**Town of Duanesburg
Zoning Board of Appeals
July 19th, 2022**

Town of Duanesburg
Zoning Board Minutes
June 21st, 2022
Draft Copy

**TOWN OF DUANESBURG ZONING BOARD OF APPEALS
RESOLUTION ISSUING INTERPRETATION OR IN THE ALTERNATIVE
APPROVING AN AREA VARIANCE TO ALLOW EIGHT FEET TALL FENCES
AT THE OAK HILL SOLAR PROJECTS**

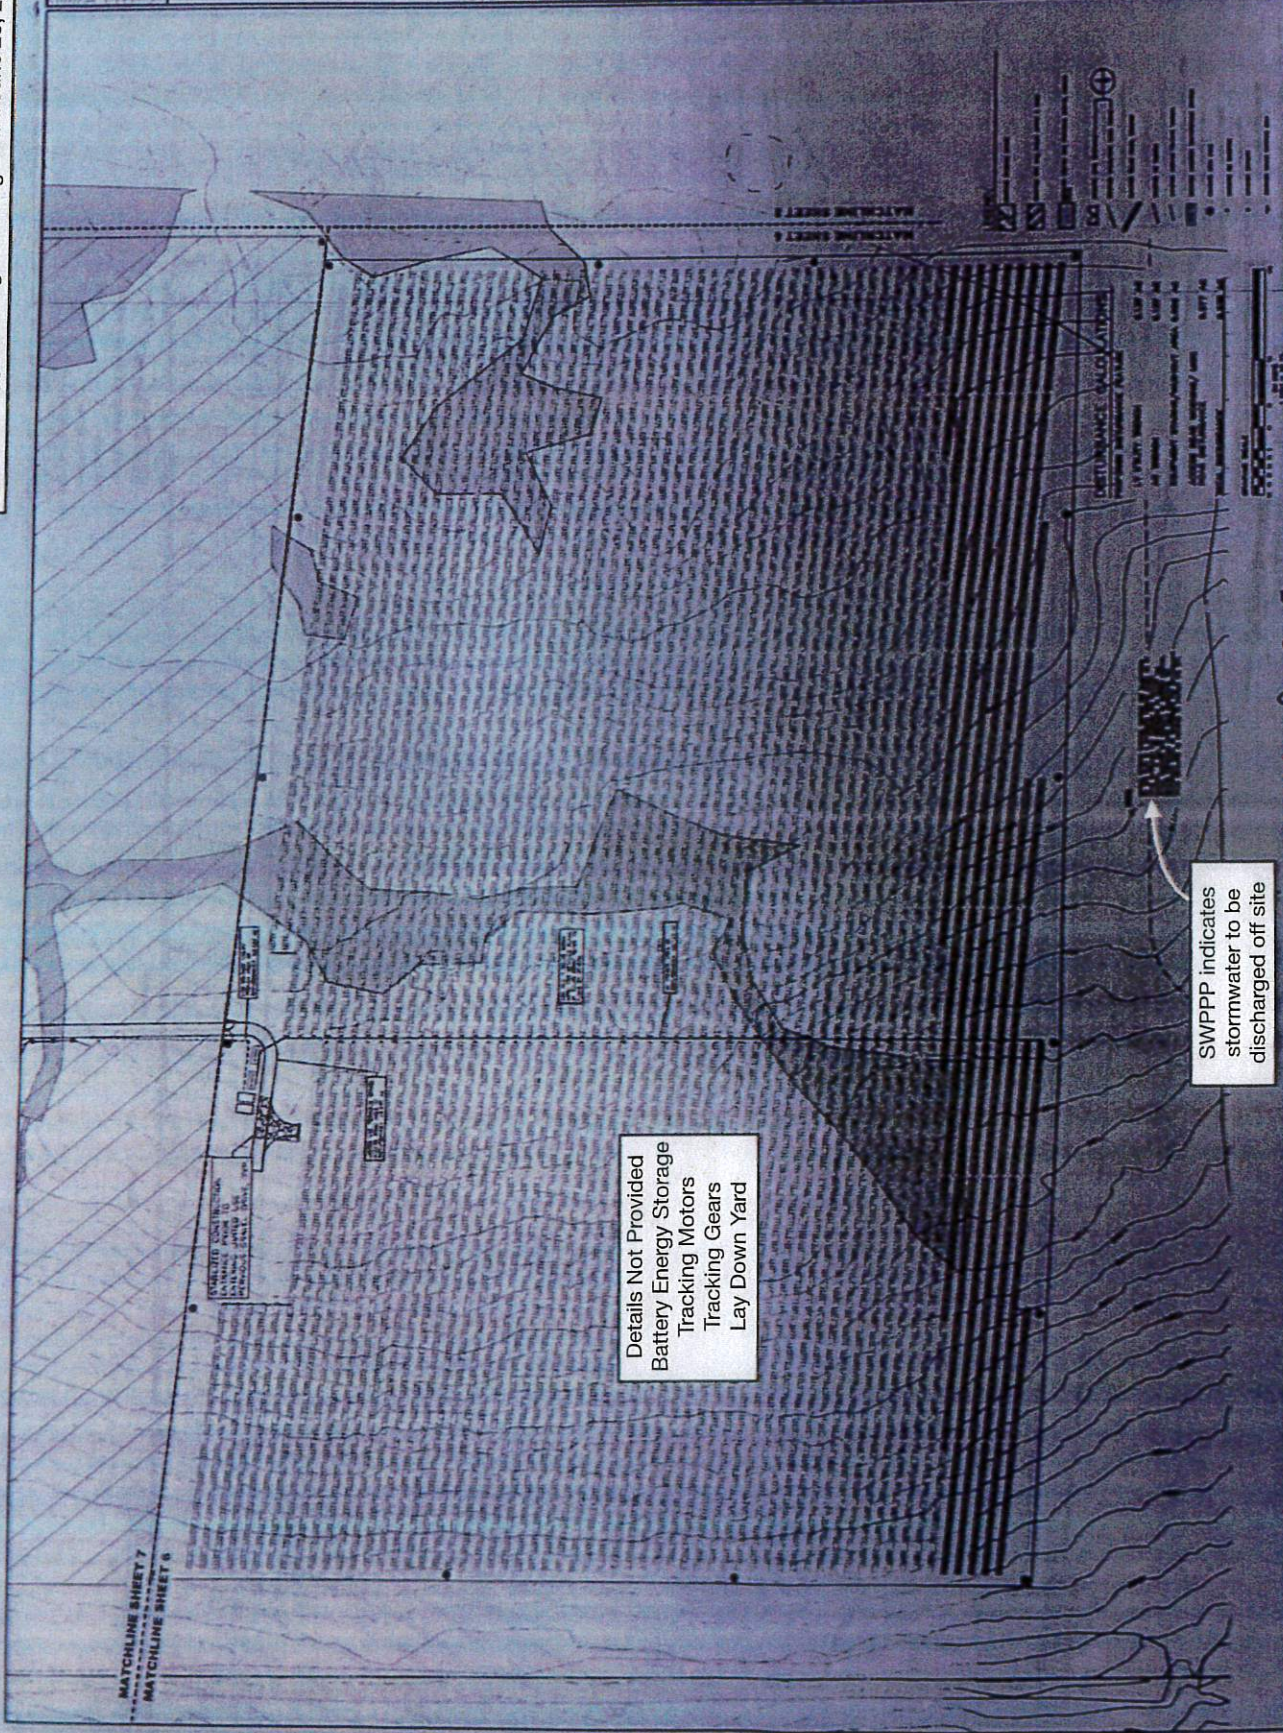
Sheet 5 and 6 of 10 The SWPPP reflects stormwater is discharged off site and the site plan reflects minimal silt fences to provide stormwater management. Abutters repeatedly requested that additional stormwater management practices be employed.

Details Not Provided
Battery Energy Storage
Tracking Motors
Tracking Gears
Lay Down Yard

Lay Down Yard not provided

The SWPPP indicates stormwater to be discharged off site. The only stormwater prevention provided is a Silt Fence.

PROPOSED SITE PLAN FOR
OAK HILL SOLAR 1&2
APPLICANT: OAK HILL SOLAR 1, LLC/OAK HILL SOLAR 2, LLC
DATE: 08/14/2020
SCALE: AS SHOWN
DRAWN BY: J. BROWN
CHECKED BY: J. BROWN
APPROVED BY: J. BROWN

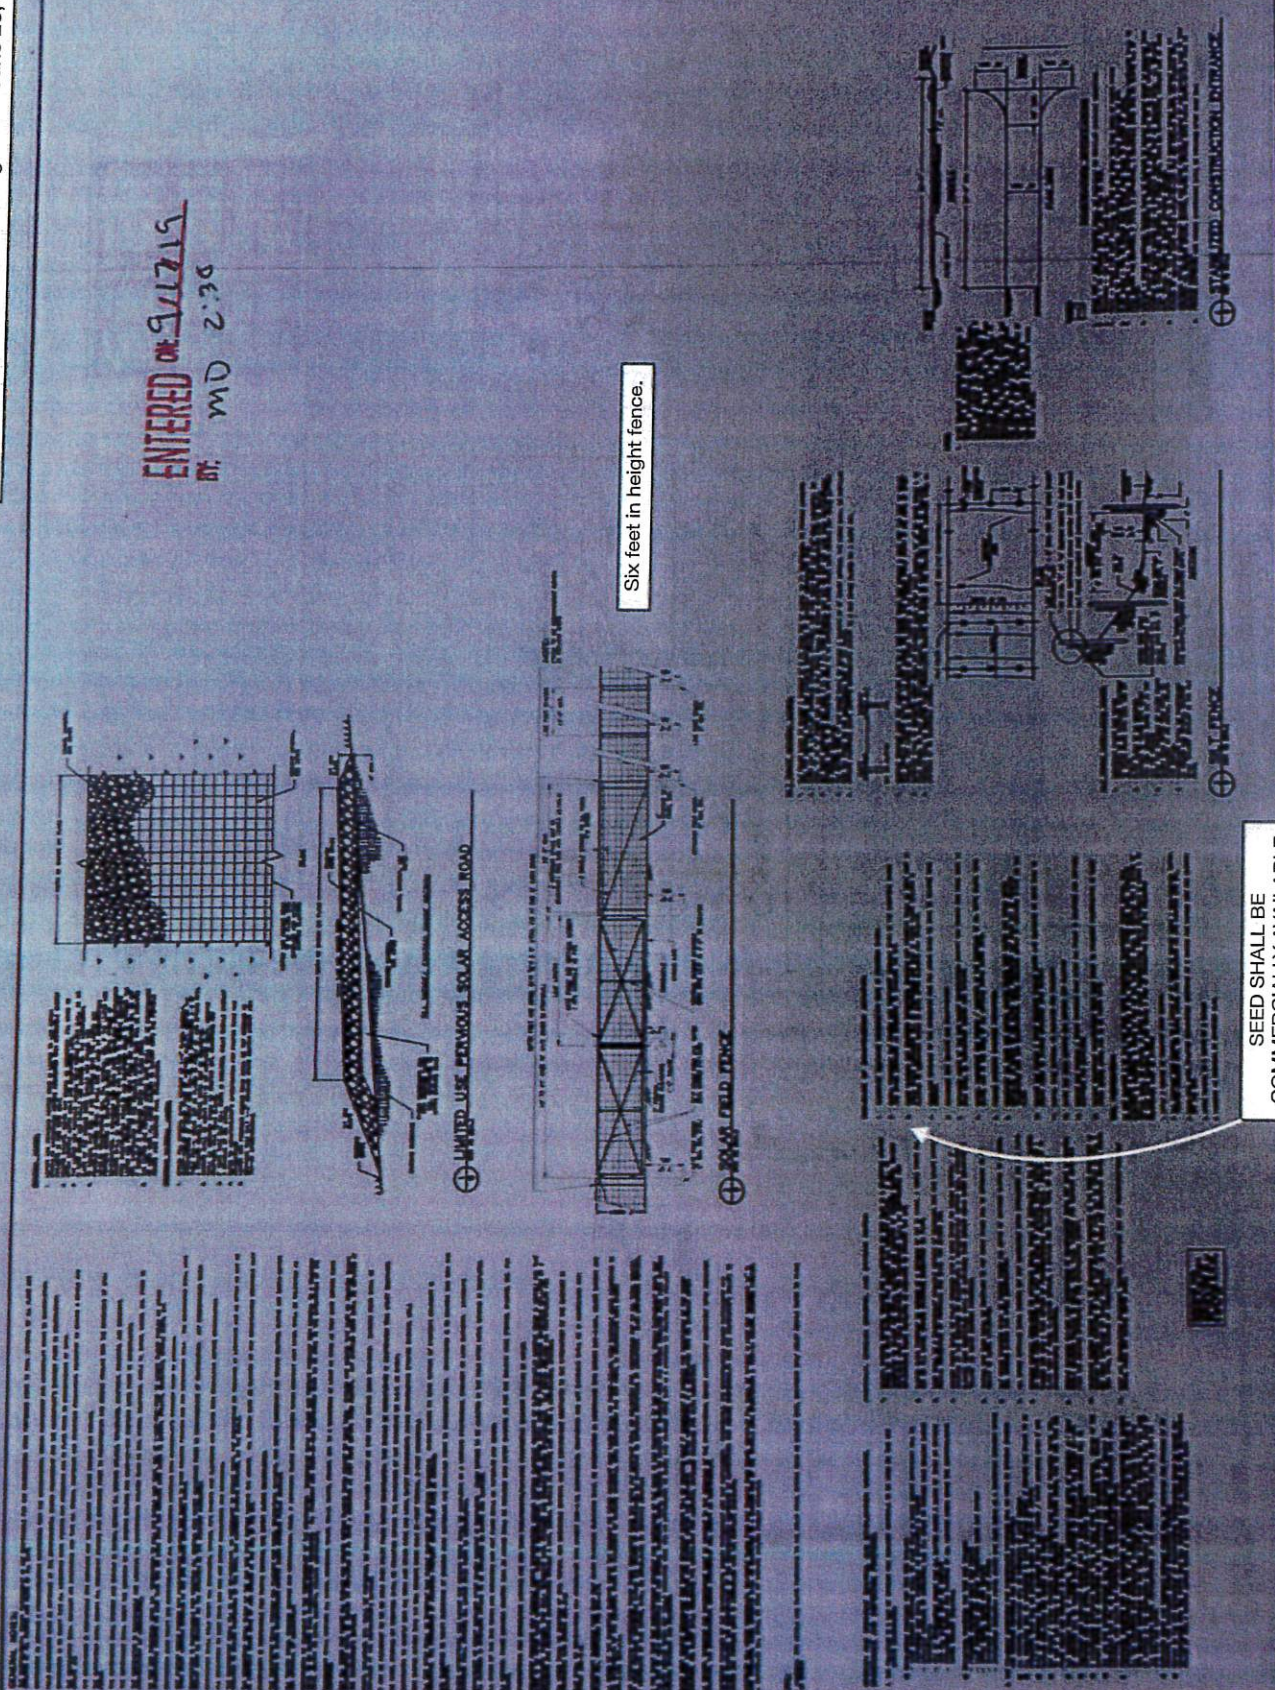
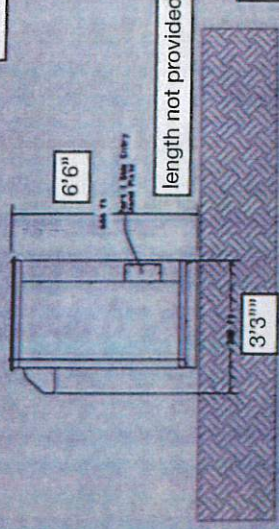
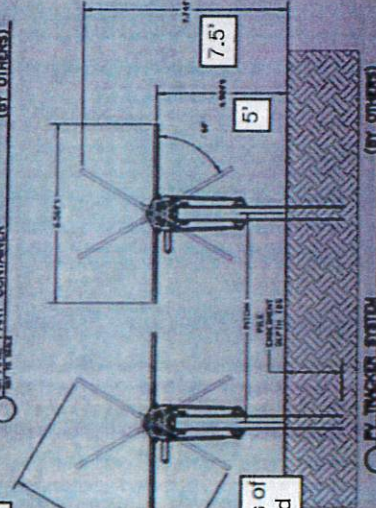
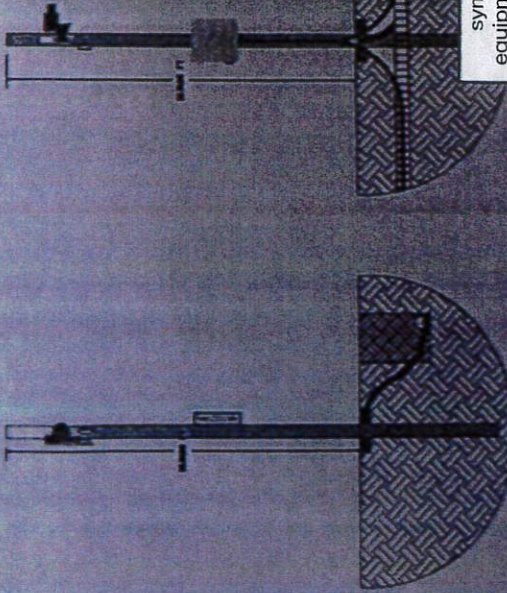
Sheet 10 of 10: omission of battery energy storage, omission of switchgear, omission of control gear, omission of length width and height for equipment. The Project did not change.

Six feet in height fence.

Wire is not in conduit.
Wire may not be removed
at decommissioning.
Wire coatings are known
to contain PFAS.

symbol for dirt
equipment pad not provided

length not provided

distance between rows of
panels is not provided

Module Length
is not provided

length not provided

symbol for concrete
equipment pad is provided
